Economic Commission for Europe**Inland Transport Committee****World Forum for Harmonization of Vehicle Regulations****Working Party on General Safety Provisions****118th session**

Geneva, 30 March-3 April 2020

UN Regulation No. 55 (Mechanical couplings)**Proposal for Supplement 9 to the 01 series of amendments
and for the 02 series of amendments to UN Regulation No. 55
(Mechanical couplings)****Submitted by the expert from Finland***

"3.4. Minimum articulation of the coupled drawbar eye

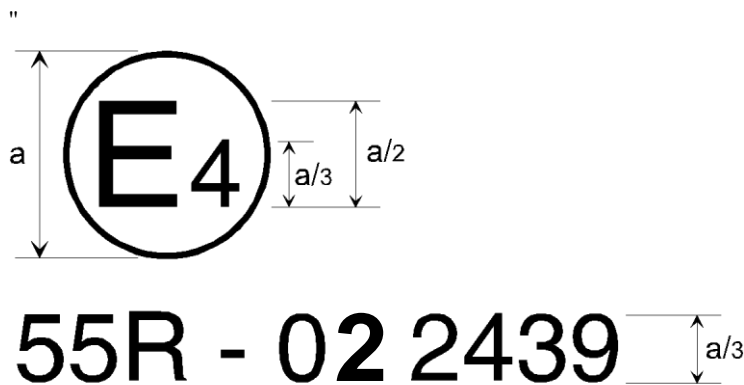
Paragraph 3.4., amend to read:

The drawbar eye, when coupled to a drawbar coupling but not fitted to a vehicle, shall have the degrees of articulation given below. If part of the articulation is provided by a special joint (Class C50-X drawbar couplings only), the field of application, given in the communication form shown in Annex 1, shall be restricted to the cases stated in Annex 7, paragraph 1.3.8. **Any flexible components providing part of the articulation are not considered to be a special joint."**

1. In case part of the articulation is provided by flexible components the current wording leaves room for interpretation. Approval documentation of the C50 coupling devices on the market show the use restriction according to Annex 7, paragraph 1.3.8. has not been used in case of flexible components providing part of the articulation. Apparently, at the moment current wording has been widely interpreted according to this clarified proposal.

"4.1. General requirements for drawbar eyes of Class D50:

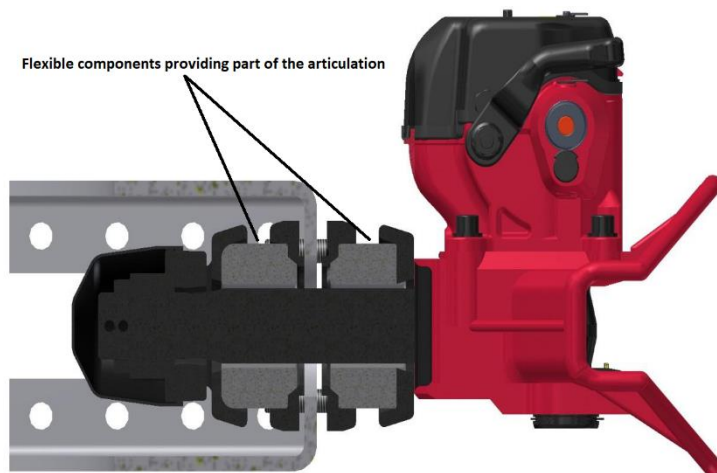
Paragraph 4.1., amend to read:

If Class D50 drawbar eyes are fitted with sleeves, they shall comply with the dimensions shown in Figure 9 (not permitted for Class D50-C) or Figure 10. The sleeves shall not be welded into the drawbar eyes. Class D50 drawbar eyes shall have the dimensions given in paragraph 4.2. The form of shank for drawbar eyes of Class D50-X ~~is not specified, but~~ **shall be limited by the form drawn in Figure 11 and** for a distance of 210 mm from the centre of the eye the height "h" and the width "b" shall be within the limits given in Table 6."

2. High capacity vehicle combinations made possible in Finland require high D-value coupling devices. This means the dimensions of the coupling devices are often very near to the limits of the current regulations. In Finland incompatible type-approved drawbar eyes and drawbar couplings has been found in the market surveillance. The main issue is the vertical thickness of the shank of the drawbar eye. Maximum dimensioned D50-X shank cannot fully articulate inside of C50 drawbar couplings as shown in the photographs below.

Clarified dimensioning of the D50-X shank would ensure the compatibility with the C50 couplings.
